20 August 2019

# RE: CANYON MINE CLOSURE AND AQUIFER PROTECTION PERMIT

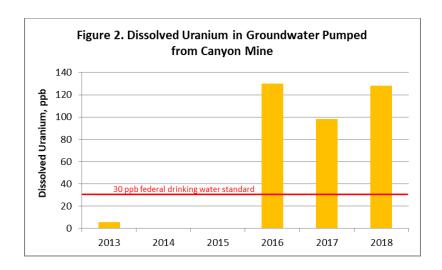
Just as regulators had been warned, construction of the mine shaft at Canyon Mine in 2016 and 2017 pierced perched aquifers associated with the Coconino Formation, causing ongoing severe flooding of the mine with groundwater. According to reports submitted to ADEQ by Energy Fuels, groundwater flooding increased from more than 900,000 gallons in 2016 to more than 8 million gallons in 2017<sup>12</sup> and nearly 10 million gallons in 2018 (Figure 1).
